REGIONAL REVIEW FINDING

ARC REVIEW CODE: R1808061

Name of Proposal: Decatur Landing (DRI 2820)

DECATUR LANDING DRI
DeKalb County
Natural Resources Group Review Comments
July 31, 2018

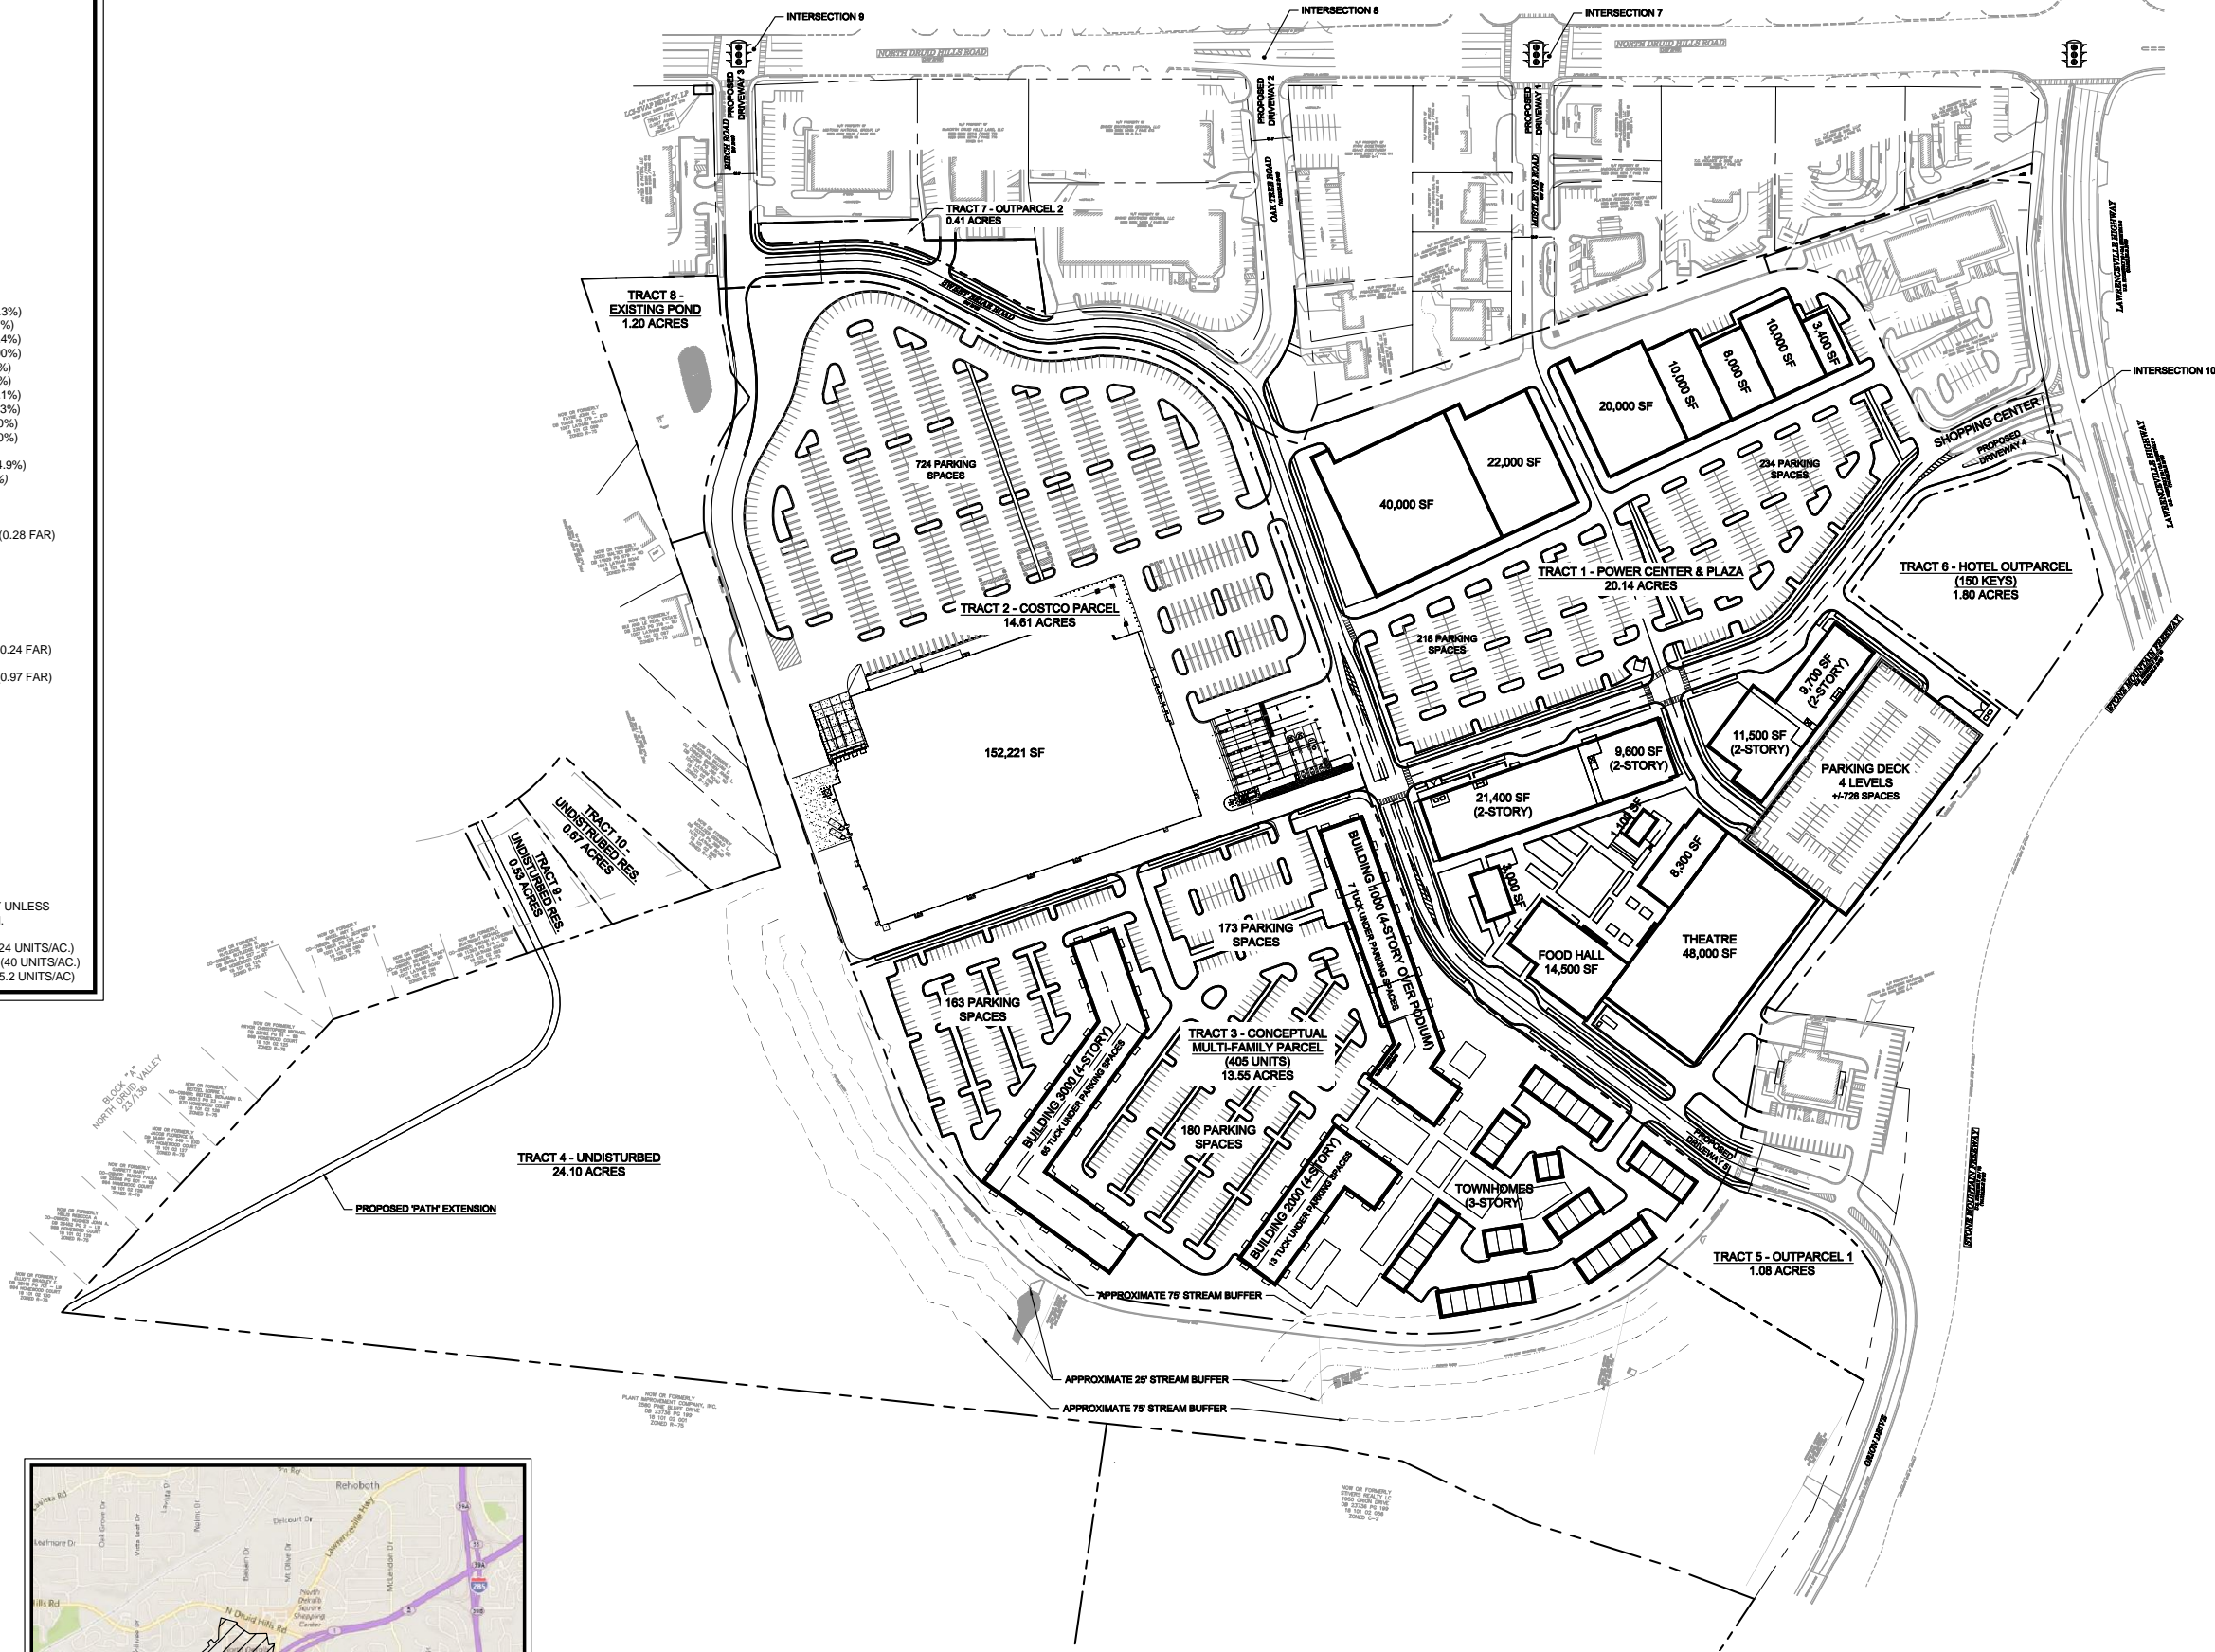
To capitalize on this potential, care should be taken to ensure that the development promotes an interconnected, functional, clearly marked and comfortable pedestrian experience on all streets, paths and parking areas. This is particularly important in terms of connections between each tract within the site, some of which are oriented very differently, for different user groups. Both Tract 2/Costco and the strip retail on the north side of Tract 1 are more automobile-oriented, and are separated by considerable distance and street crossings from the more pedestrian-oriented activity node in Tract 1, around the food

hall/movie theater plaza and residential area plaza. Tract 2/Costco is particularly disconnected from the rest of the development. There is no apparent pedestrian pathway or crosswalk connecting Costco, which is oriented toward its parking lot and N. Druid Hills Rd., to any other part of the DRI. Finally, while Tracts 1 and 3 adjoin each other on the south side of the site, it does not appear that there is a crosswalk or other pedestrian facility directly between the food hall/pedestrian plaza in Tract 1 and the residential area/pedestrian plaza in Tract 3. These areas should be more strongly connected across the north-south spine road, and pedestrians – including site residents – should not be expected to cross only at the intersection of the two spine roads to the north. The development team is also encouraged to ensure that end-of-trip facilities (bicycle racks, etc.) are provided for residents, workers and visitors at key locations throughout the site.

pedestrian facilities currently exist along roadways adjacent to the site. The site plan does not appear to provide new or additional bike/ped facilities.

The traffic analysis includes significant reductions in traffic impacts for mixed-use and alternative transportation modes; however, the site design includes a more than 80 percent increase over the required parking. This, coupled with the isolated parking and building separations, promotes a more vehicle-oriented development. The site should maximize the opportunity for creating a more pedestrian/bike-friendly development as well as take advantage of existing facilities.
